<p><b>SUNDRY NOTICES AND REPORTS ON WELLS</b> (DO NOT USE THIS FORM FOR PROPOSALS TO DRILL OR TO DEEPEN OR PLUG BACK TO A DIFFERENT RESERVOIR. USE "APPLICATION FOR PERMIT" (FORM C-101) FOR SUCH PROPOSALS.)</p>		<p>WELL API NO. 30-015-22641</p>
<p>1. Type of Well: Oil Well <input checked="" type="checkbox"/> Gas Well <input type="checkbox"/> Other <input type="checkbox"/></p>		<p>5. Indicate Type of Lease STATE <input checked="" type="checkbox"/> FEE <input type="checkbox"/></p>
<p>2. Name of Operator Rover Operating, LLC</p>		<p>6. State Oil &amp; Gas Lease No. E-5668</p>
<p>3. Address of Operator 1255 W 15<sup>th</sup> St., Ste 700 Plano, TX 75075</p>		<p>7. Lease Name or Unit Agreement Name Tidewater K State</p>
<p>4. Well Location Unit Letter <u>A</u> : <u>330</u> feet from the <u>North</u> line and <u>330</u> feet from the <u>East</u> line Section: <u>2</u> Township: <u>17S</u> Range: <u>31E</u> NMPM County: <u>Eddy</u></p>		<p>8. Well Number #6</p>

## CONDITIONS FOR PLUGGING AND ABANDONMENT

ROVER OPERATING, LLC  
WELLBORE DIAGRAM

**TIDEWATER K STATE #6**

# **ROVER OPERATING, LLC** **WELLBORE DIAGRAM**

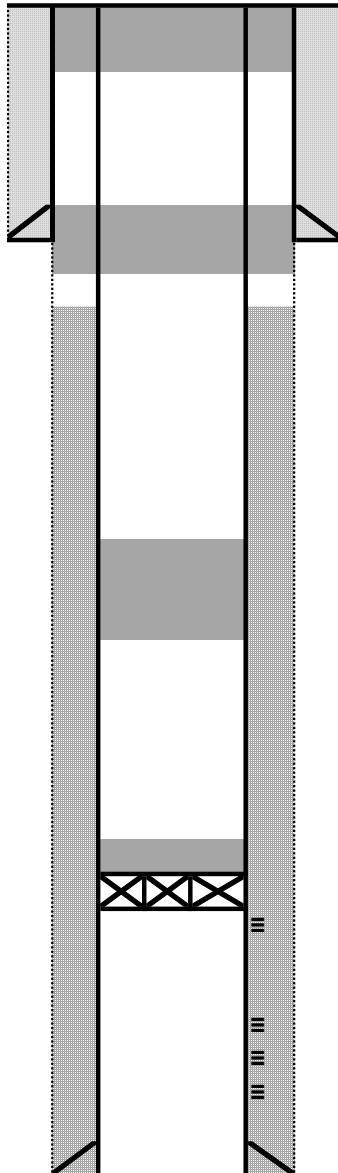
Notify OCD 24 hrs. prior to any work done

\*\*\*SEE ATTACHE COA's\*\*\*

- Prep loc. MIRU, POOH w/ rods and pump, laying down, ND WH. NU BOP. Release TAC, POOH tubing, laying down. **Run CBL**
- RU Wireline, RIH w/ gauge ring.
- Set 5-1/2" CIBP @ 2950' w/35' cmt, circ w/P&A mud. Test to 500 psi. WOC & Tag.
- Spot 80 sx 1985'-2380'. WOC & Tag.
- 35 sx 758-858', P.S. & Tag
- 35 sx 100'-Surf. P.S. Attempt to circ cmt to surf. Verify ND BOP.
- Cut off WH 3' below GL. Install 4" diameter 4' tall above ground marker. Cut off mast anchors 3' below GL. RD MO.
